BEFORE THE DUNEDIN CITY COUNCIL

Land Use Consent Application to
construct and operate a commercial
residential development by NZ
Horizons Hospitality Group Limited.

STATEMENT OF EVIDENCE OF ANDREW DAVID CARR
Transportation
24 July 2017

Annexure F: Examples of Transition Ramps

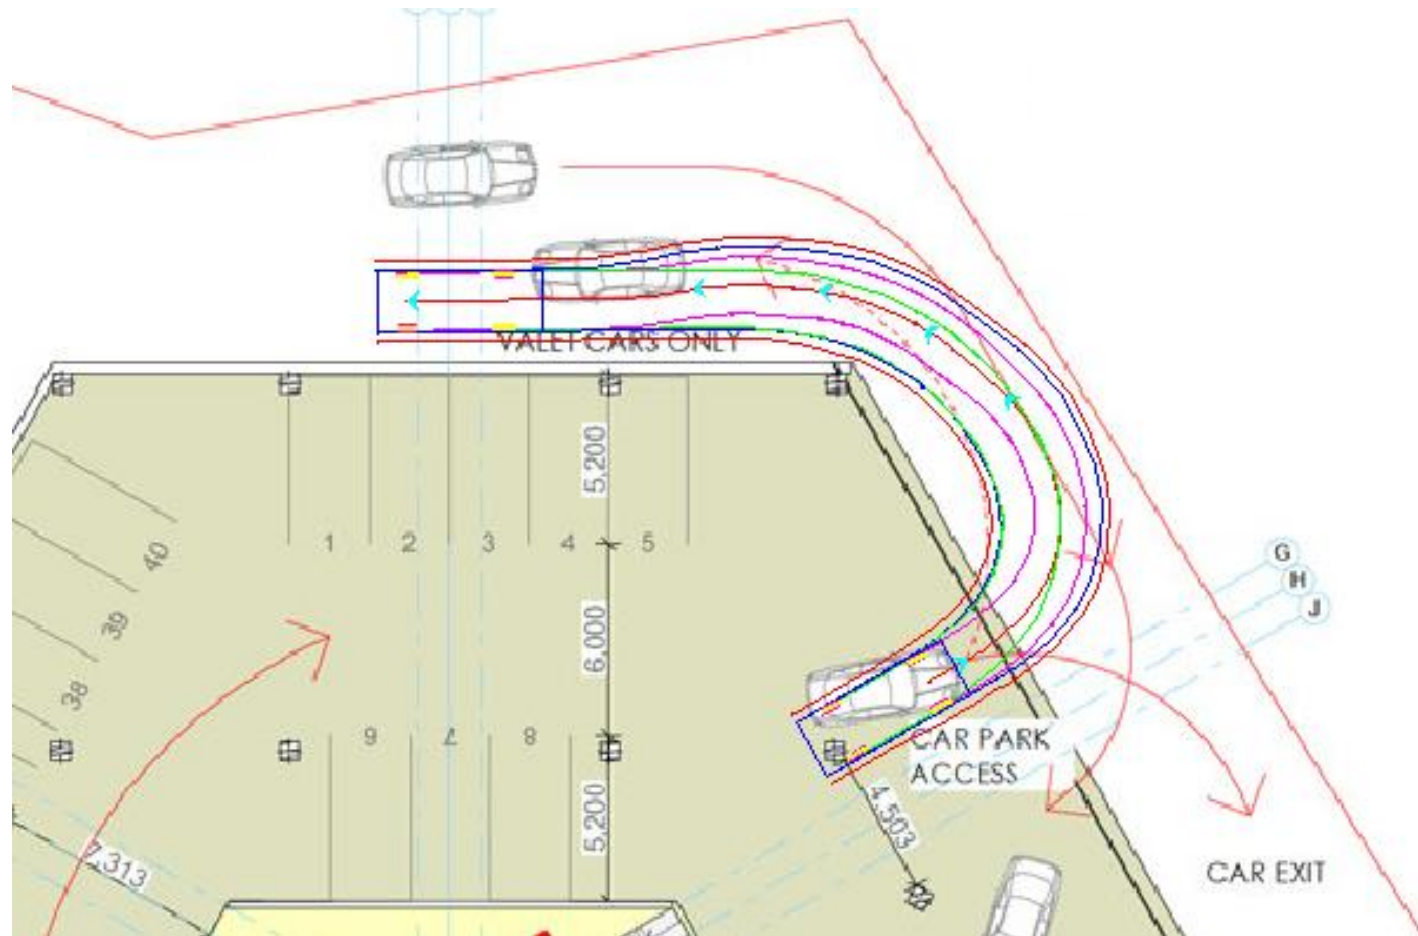
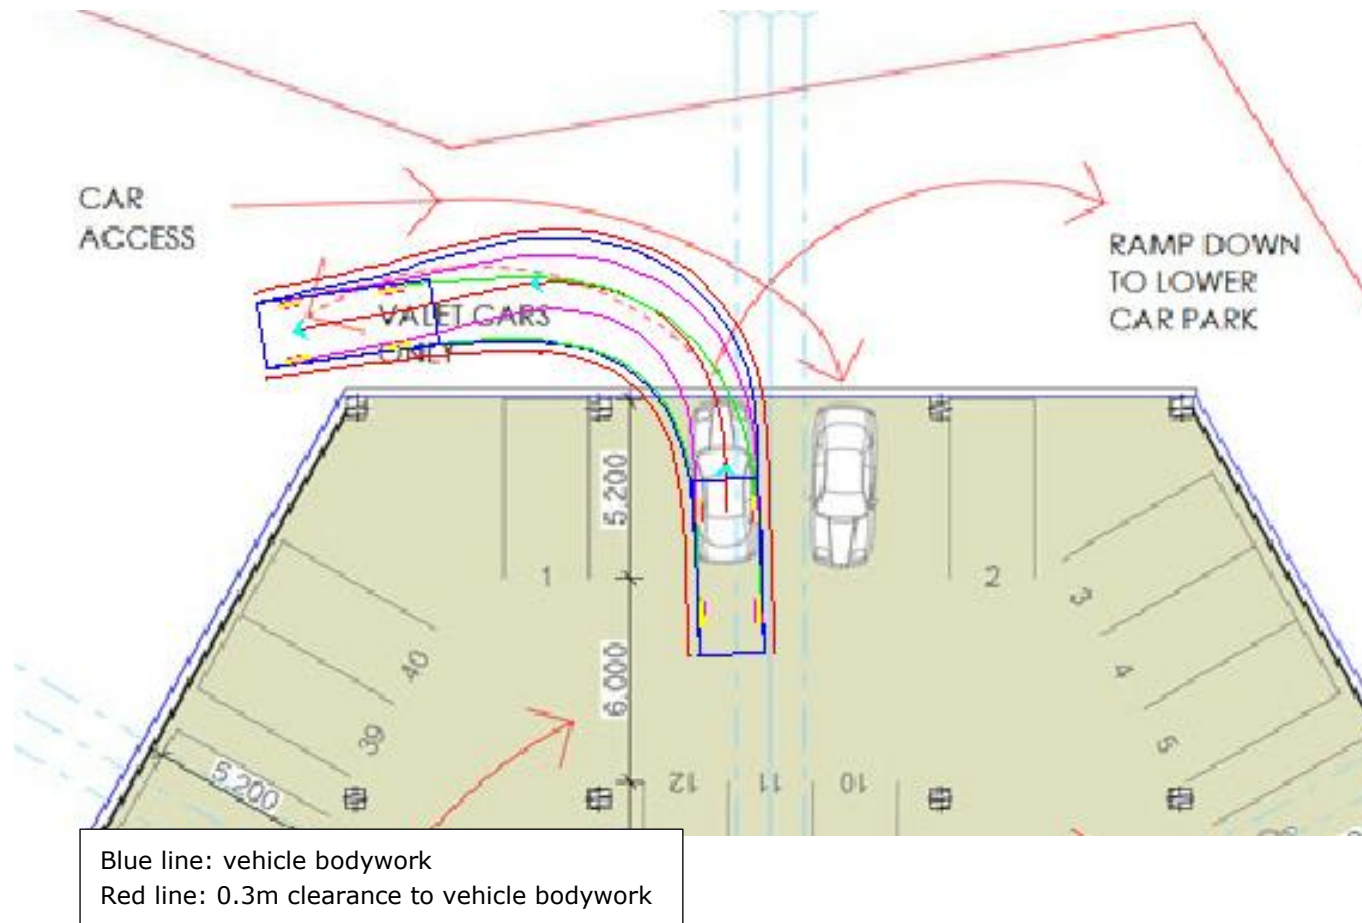
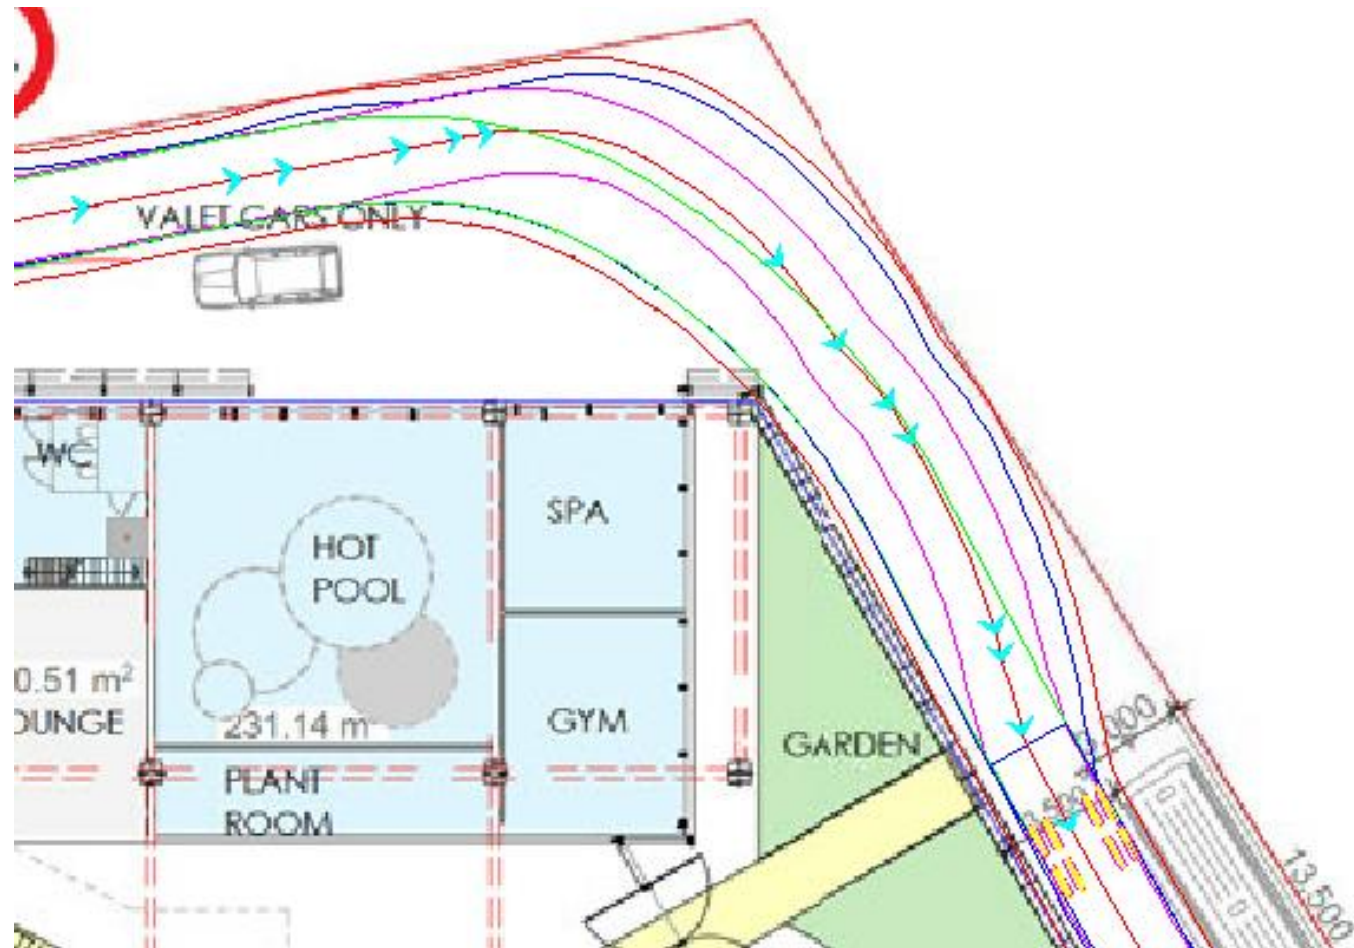
- 34 An example of a transition ramp is shown in Annexure F. It can be seen that one outcome of simply adding a transition ramp at the foot of the ramp is that the ramp is extended slightly. In order to keep the ramp length the same, the gradient of the ramp has to be made steeper.

- 41 As I set out above, one solution to reducing the rate of change of gradient is to use transition ramps. In this case, the length of the ramps cannot be extended because of the need to retain flatter areas immediately adjacent to the parking and loading accesses. This then means that the main part of the ramp needs to become steeper (as illustrated in Annexure F).
